## S&S Worldwide service bulletin – restraint upgrade

# Service Bulletin

**Abstract Of Issue:** Tower Restraint Upgrade

**Option 2** - Remove single hydraulic restraint and replace with dual mechanical bumpy rod restraint.

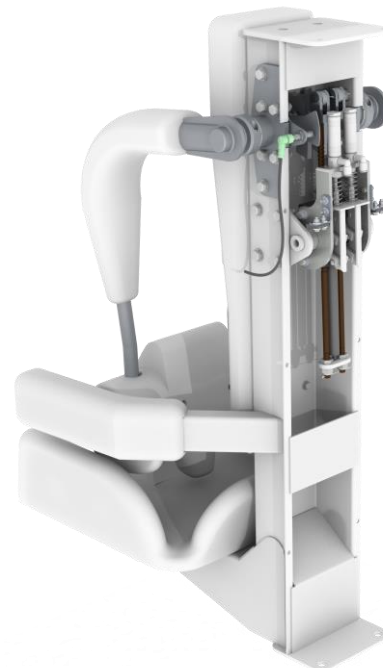
- Second restraint mechanism for redundancy.
- Proven mechanical bumpy rod system replaces hydraulic system.
- Ability to measure minimum closed position locking of restraint pawl.
- Rework tower components as lower cost option.
- Keeps floating ride experience for passengers.
